EPC STORMWATER REVIEW COMMENTS  
IN ORANGE BOXES WITH BLACK TEXT

# VOLLMER ROAD (NORTH)

### STREET IMPROVEMENT PLAN

#### FEBRUARY 2023

**DP01 PROFILE  
STA 0+00.00 TO 2+55.94**

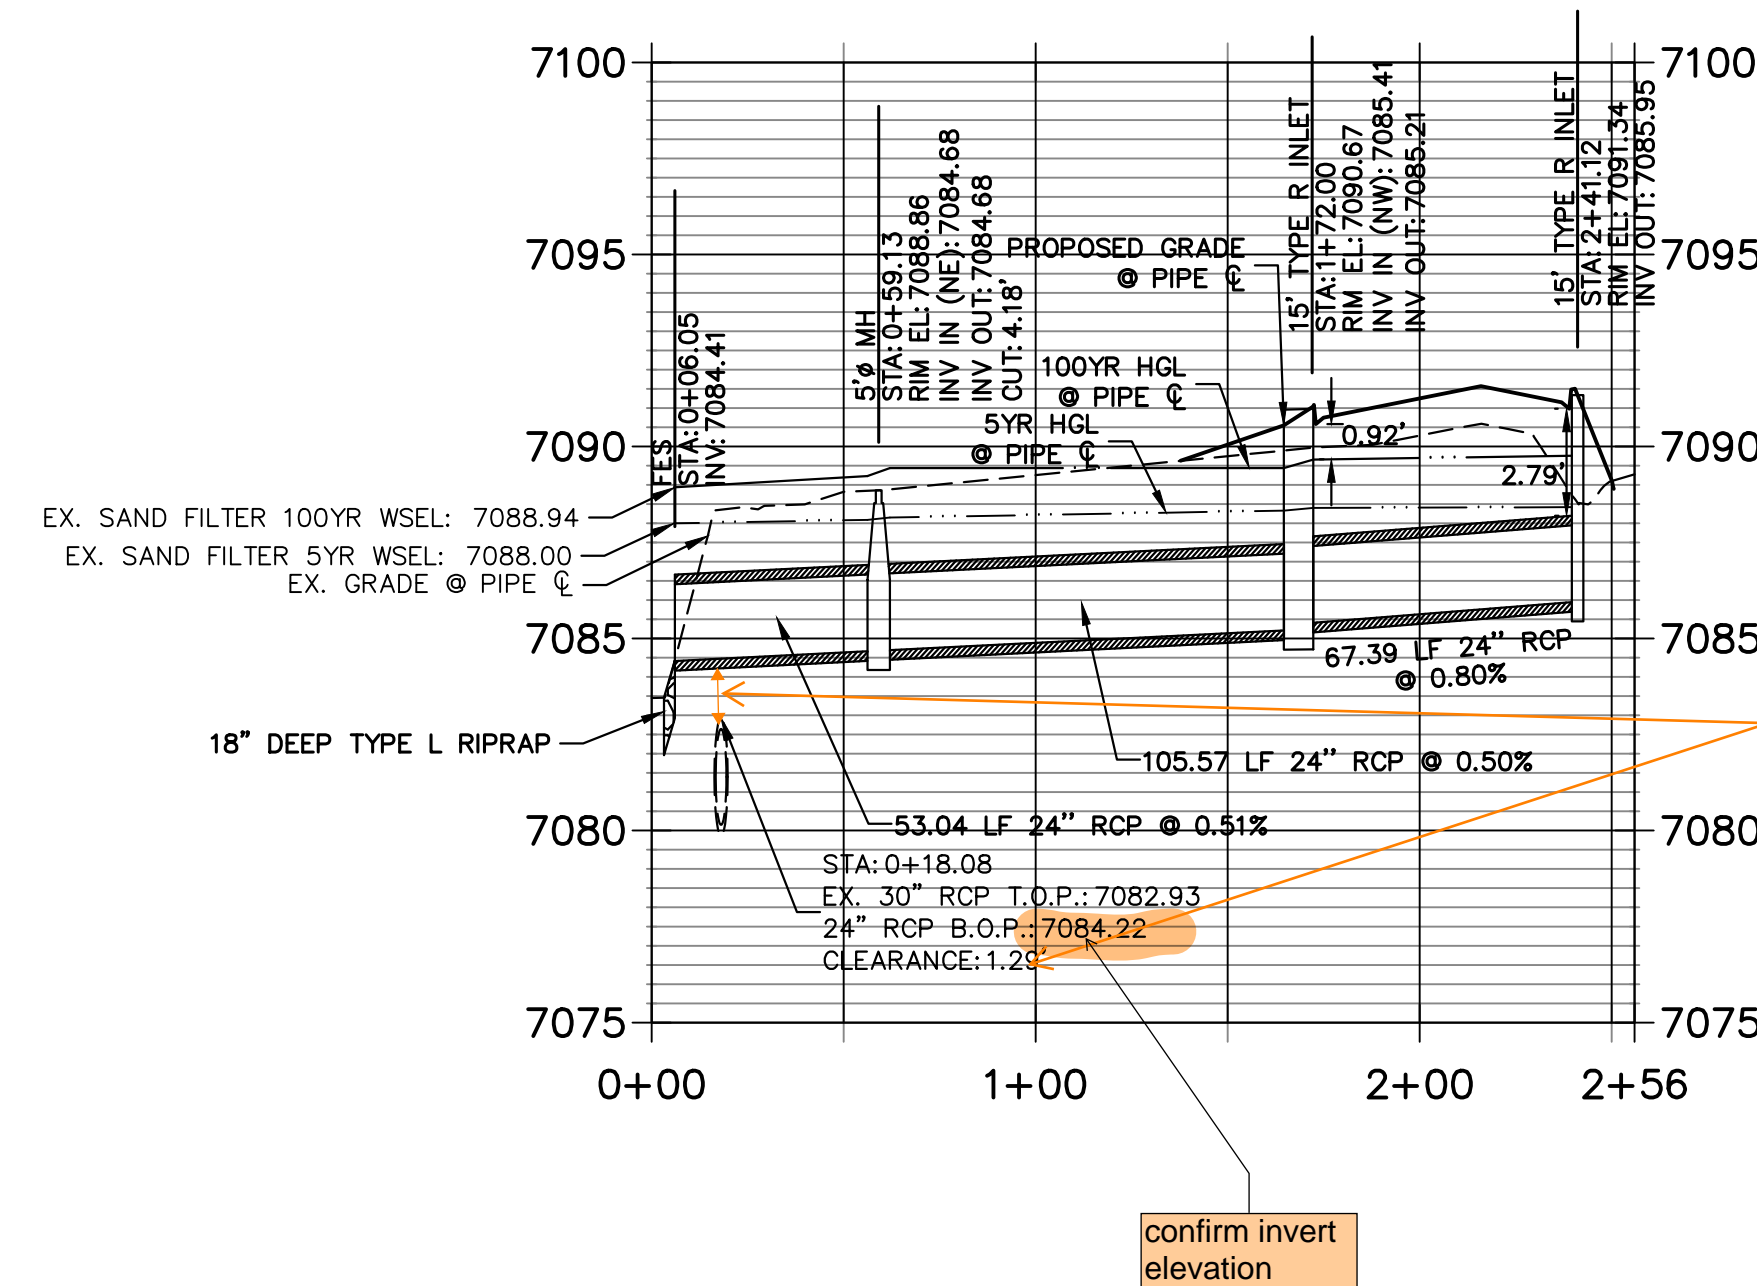
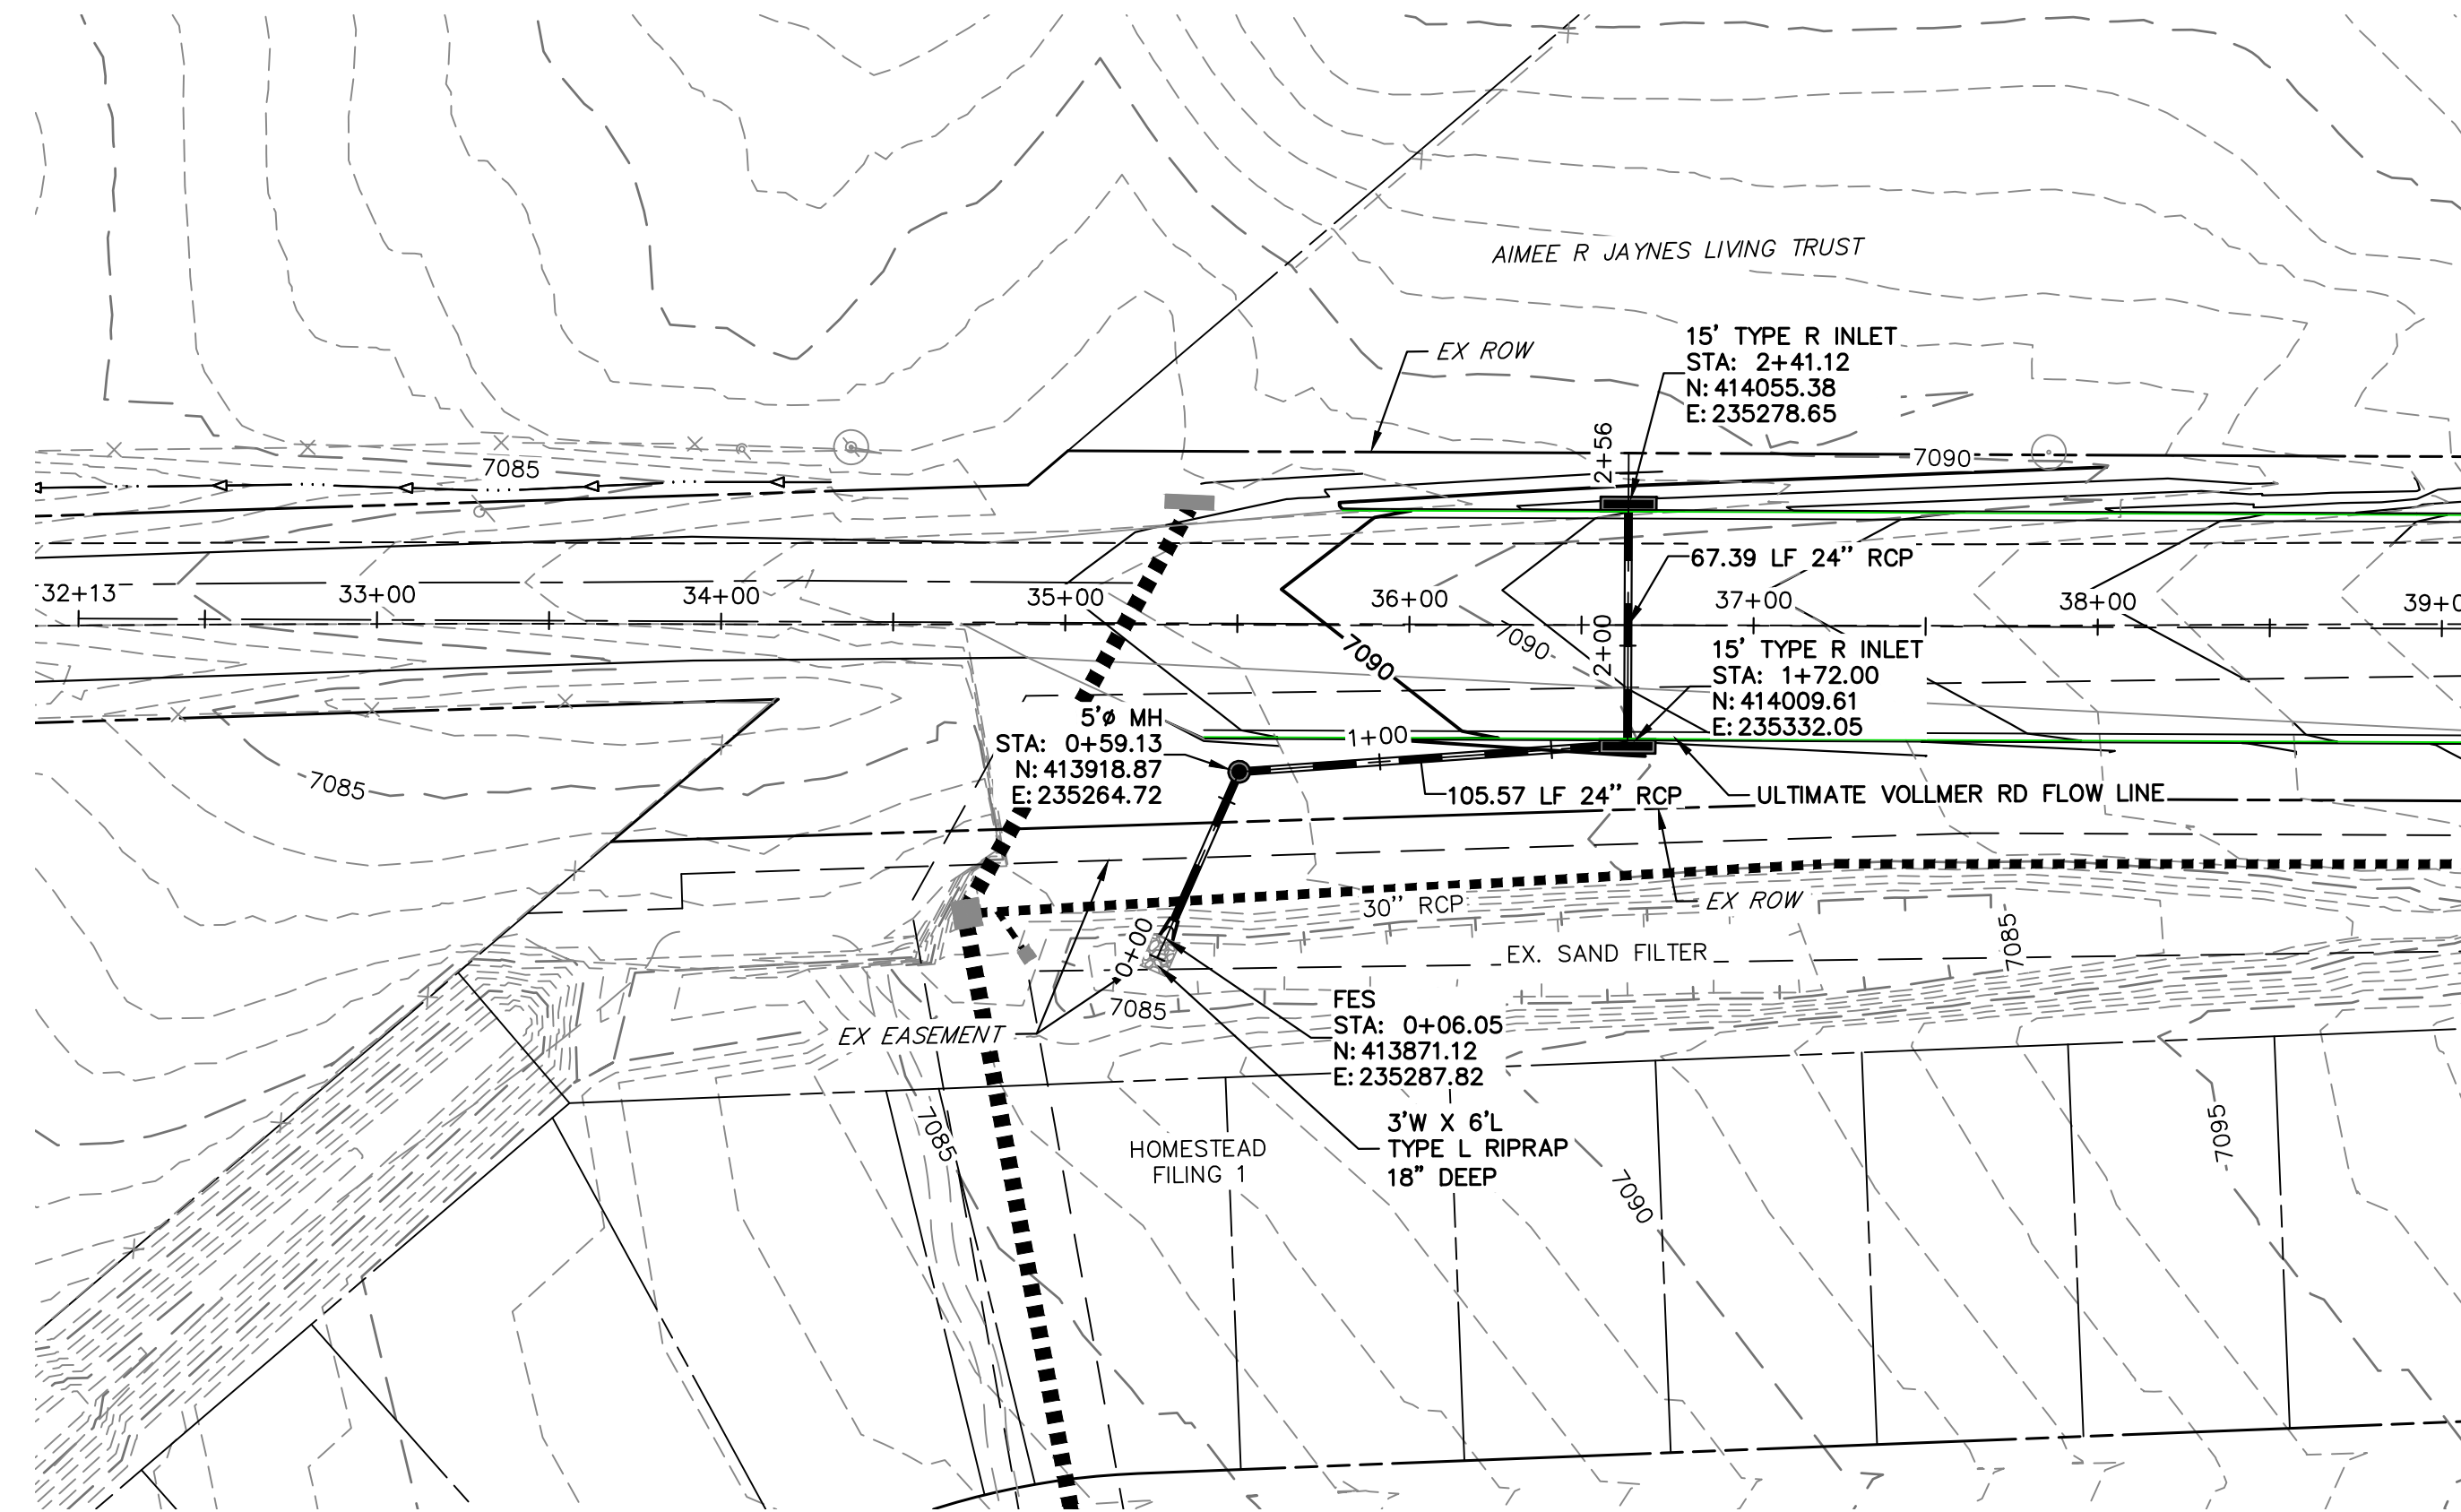
Verify the pipe thickness is included in this clearance distance provided.

confirm invert elevation

ADD WATER TIGHT JOINT WHEN 100 YR HGL SHOWS PIPE FULLY INUNDATED
